RS-14-205

Braidwood Station, Units 1 and 2
Facility Operating License Nos. NPF-72 and NPF-77
NRC Docket Nos. STN 50-456 and STN 50-457

Subject: Third Six-Month Status Report in Response to March 12, 2012 Commission Order Modifying Licenses with Regard to Requirements for Mitigation Strategies for Beyond-Design-Basis External Events (Order Number EA-12-049)

**Third Six-Month Status Report for the Implementation of Order EA-12-049, Order
Modifying Licenses with Regard to Requirements for Mitigation Strategies for Beyond-
Design-Basis External Events**

Attachment 3
Update Mechanical One Line Diagrams

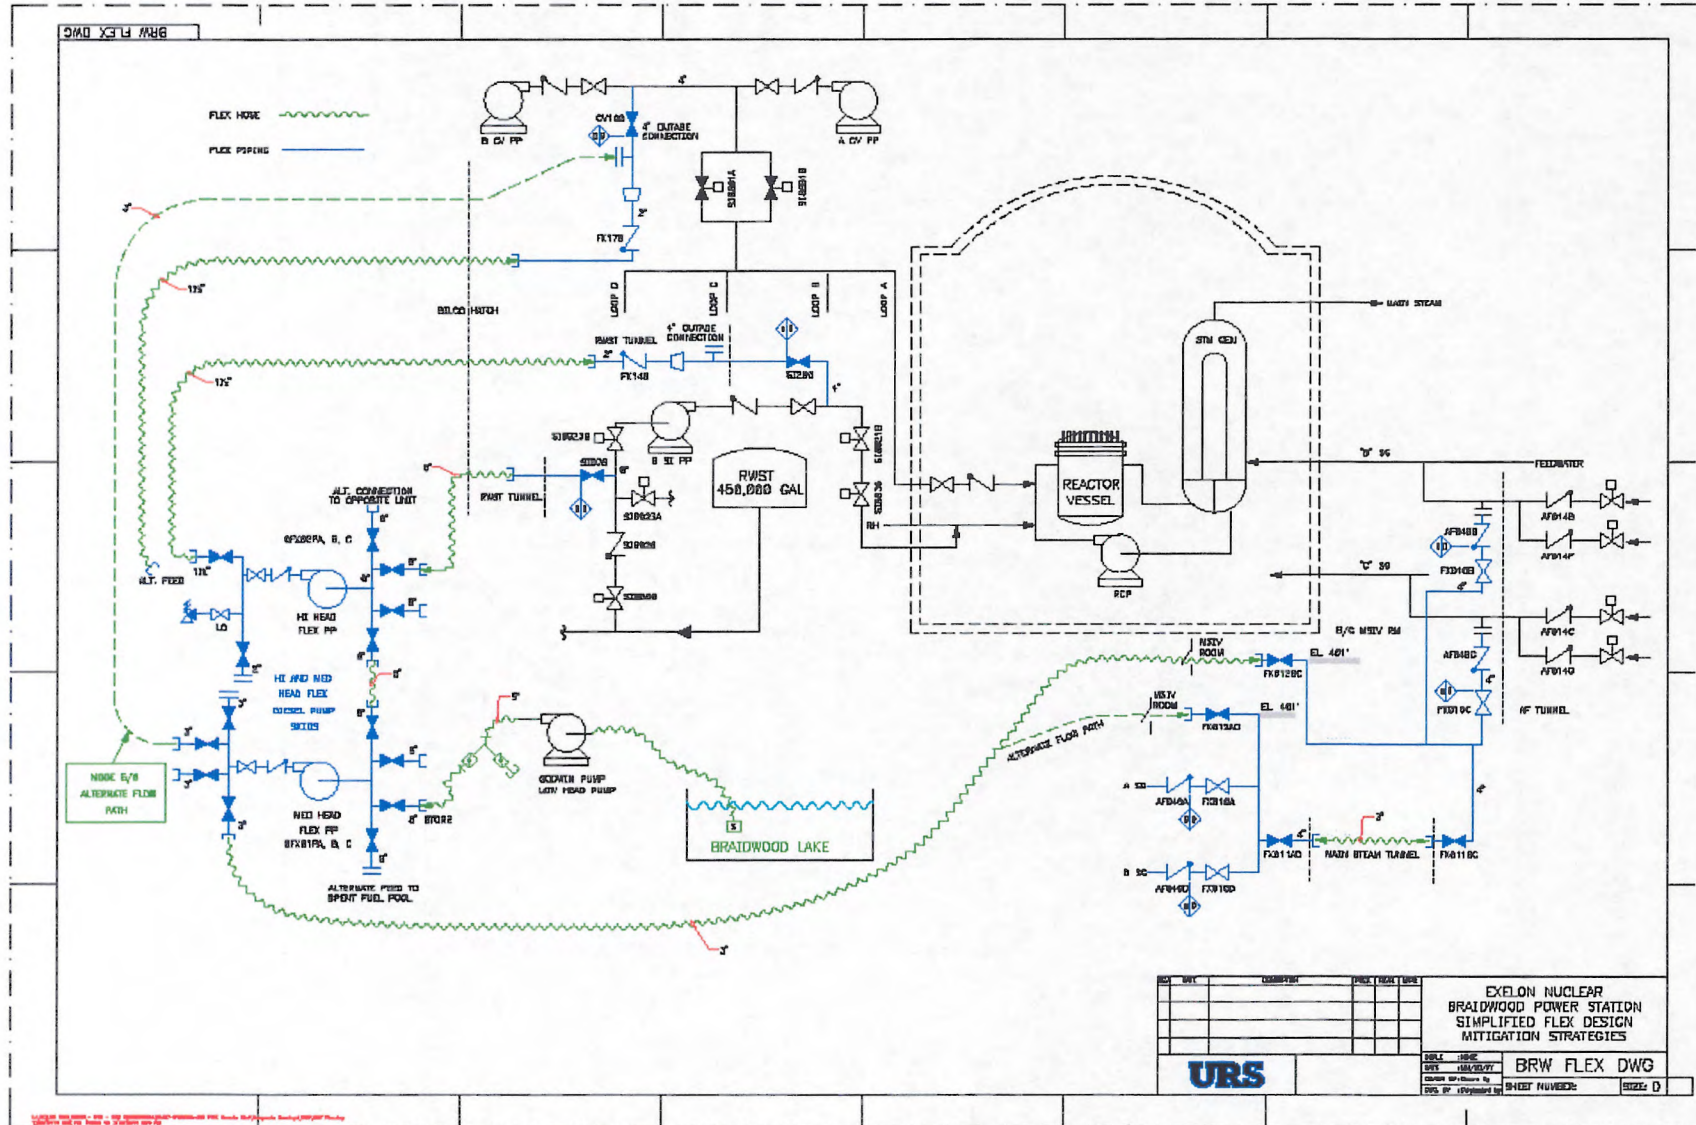
Reason for Change: Updated sketches as a result of refining the site strategy.

Change: Updated sketches are in Attachment 3 of this document
